Economic and Social Council

Proposal for Supplement 8 to the 02 series of amendments to UN Regulation No. 90 (Replacement brake parts)

Submitted by the Working Party on Automated/Autonomous and Connected Vehicles *

Figure 1

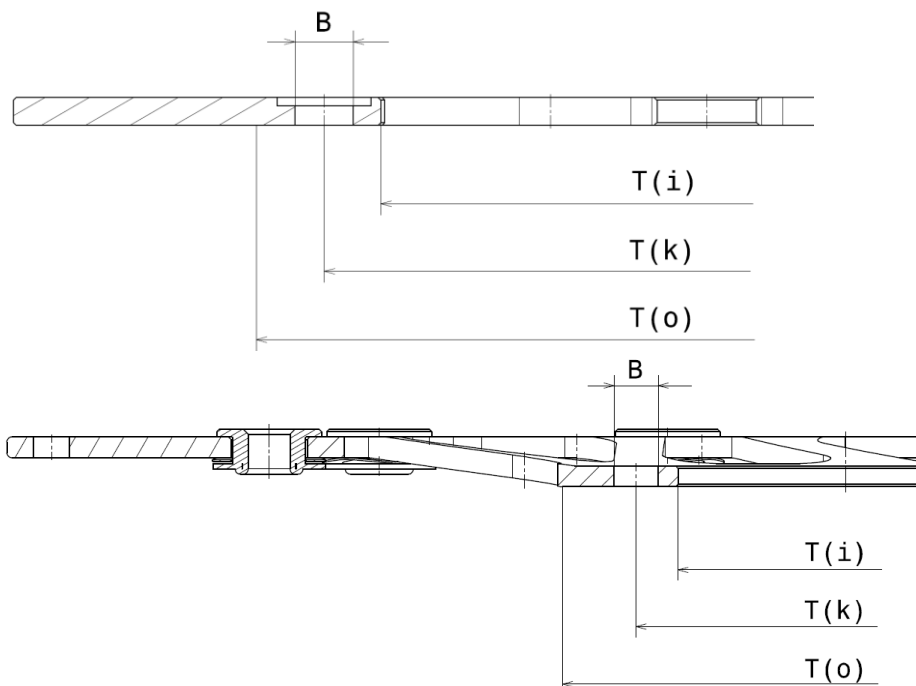
“1.5. Definition of bell mounting face

“*Bell mounting face*” means the surface of a brake disc that goes in contact with wheel hub.

The mounting surface is calculated between the disc inner diameter $T(i)$ and a diameter $T(o)$ defined as the max diameter of area subjected to flatness restrictions as indicated on disc drawing (see figure 1).

In case indications on the drawing are missing, $T(o)$ is defined as follows:

$$T(o) = T(k) + B + 10\text{mm}$$
